## PLANNING COMMISSION PUBLIC HEARING/REGULAR MEETING CITY OF FARMINGTON HILLS

#### NOVEMBER 20, 2025 @ 7:30 P.M.

# AMEND PLANNED UNIT DEVELOPMENT 12, 2014, INCLUDING SITE PLAN 60-7-2025

Subject: Site Plan Review 60-7-2025 (Twelve Mile/Orchard Lake – Culver's)

EXTERIOR ELEVATIONS, DOOR & WINDOW SCHEDULE

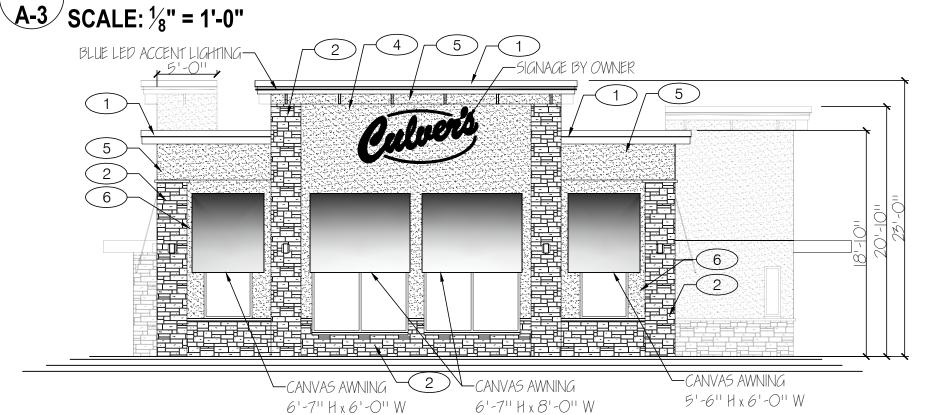
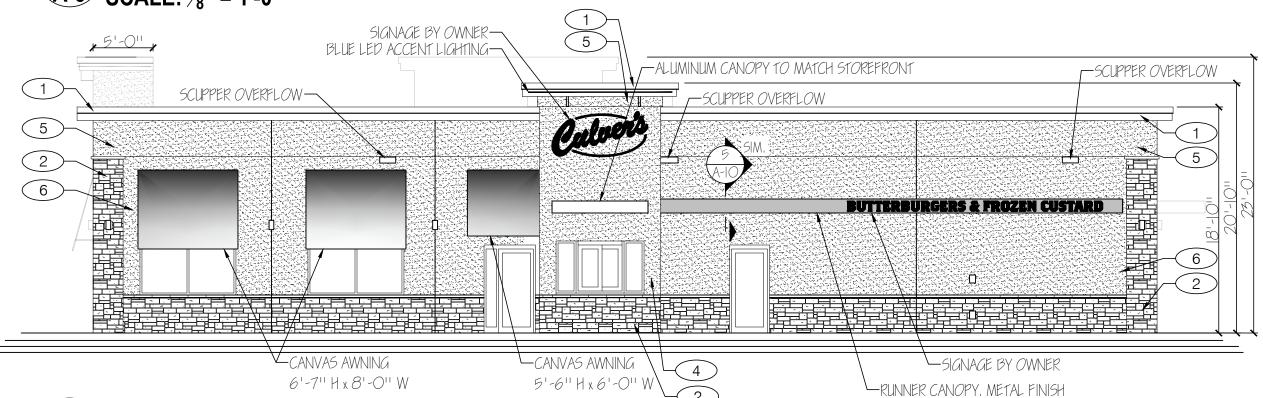
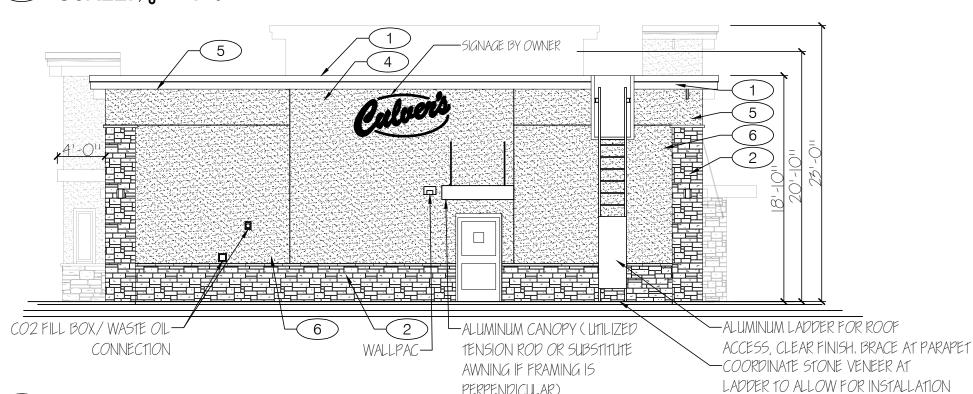
- 20. **Design Standards (34-5.20).** *Elevations appear to be mislabeled—the "left" and "right" elevations are switched; it would clearer to label these as "east" and "west" to reduce ambiguity.* The design standards of Section 34-5.20 were adopted after initial plans were submitted; these standards apply to all walls facing a public right-of-way.

- a. Building Materials. EIFS is limited to an accent material (less than 40% of façade) located not less than 8 feet above grade; this standard is not met; multiple fields of this material are located below 8 feet; percentage not known. Separate from relief granted under a PUD, the planning commission may grant relief from building material requirements when it finds that the materials are consistent with surrounding development and the waiver will achieve a specific architectural objective.

- b. Architectural scaling requirements are met.
  - c. Roof/parapet standards are met; this building will have a flat roof.
  - d. Buildings facing a major thoroughfare are required to have 60% window coverage on the ground floor. This standard appears not to be met on the southern façade. Separate from relief granted under a PUD, the planning commission may grant relief from building material requirements when it finds that the materials are consistent with surrounding development and the waiver will achieve a specific architectural objective, and that compliance with the standard will result in a practical difficulty.

ELECTRICAL PHOTOMETRIC PLAN

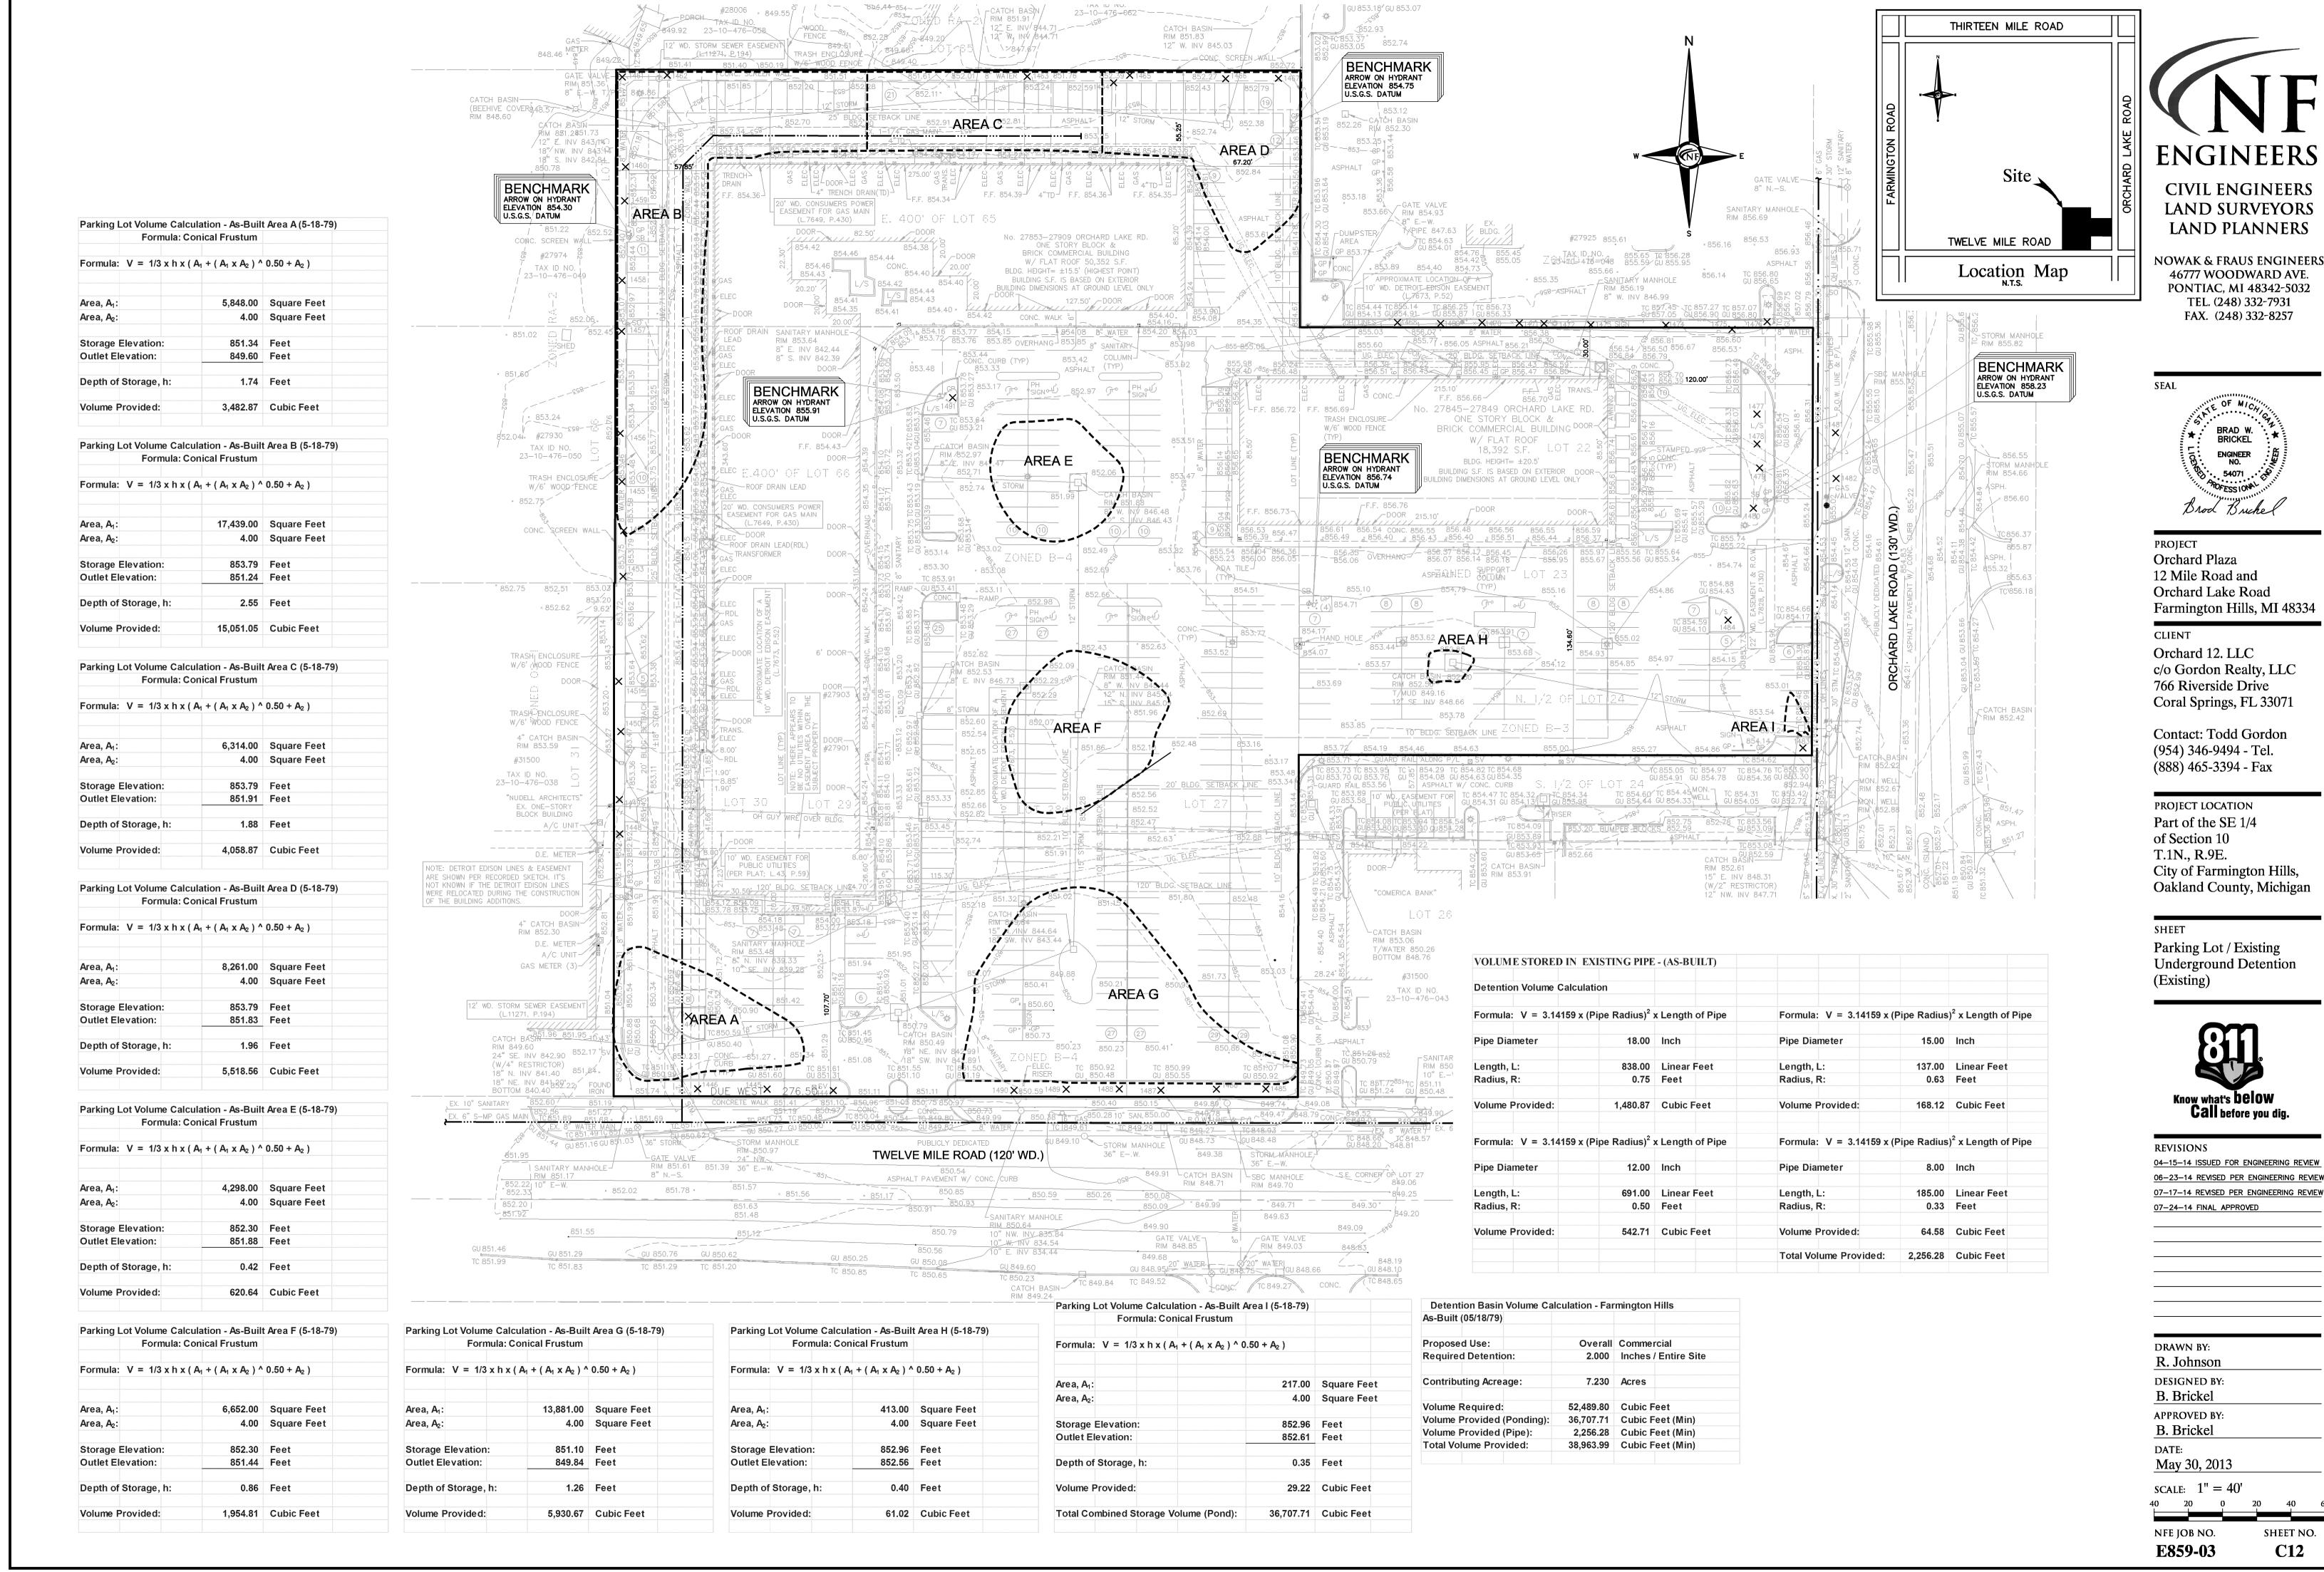
- 16. **Exterior Lighting (34-5.16)**. A photometric plan was provided showing numerous values in excess of 0.3 footcandles at the property line, though given that the site functions as part of a larger shopping center, these could be considered values internal to the site. However, these values should be observed at the south property line. Additionally:

- Proposed lighting exceeds the required 4:1 uniformity ratio.

- We were unable to review whether the site meets the maximum illumination of 2.5 lumens per sf of pavement area.
- Various notes related to lighting compliance should be added to this sheet.

- Lighting cut sheets were not provided, and compliance with cut-off requirements cannot be verified.
- 17. **Rooftop Screening (34-5.17).** Screening of rooftop equipment is required where any is provided. Mechanical equipment on the ground shall be screened per Section 34-5.1.4.D. Sheet A-8.0 clearly shows that the parapet will screen all rooftop equipment.
